STAFF REPORT: 11/12/2025 REGULAR MEETING

APPLICATION NUMBER: HDC2025-00638

ADDRESS: 3751 LESLIE

SCOPE: REPLACE WINDOWS (WORK COMPLETED WITHOUT APPROVAL) WITH ALUMINUM-CLAD WOOD WINDOWS

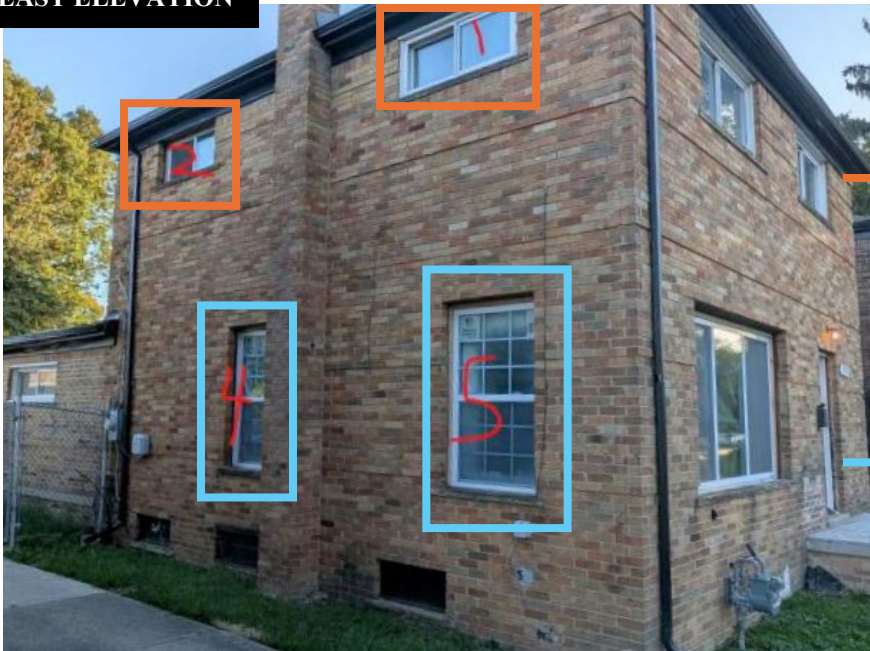
- Replace three (8) steel windows with aluminum-clad wood windows at the East and West elevations
 - NOTE: the vinyl windows were installed without the approval of the HDC and received a Notice of Denial (NOD) from the 06/11/2025 HDC regular meeting
 - NOTE: the front façade windows were given approval to replace the violation vinyl windows with aluminum-clad wood windows at the 08/28/2025 HDC regular meeting
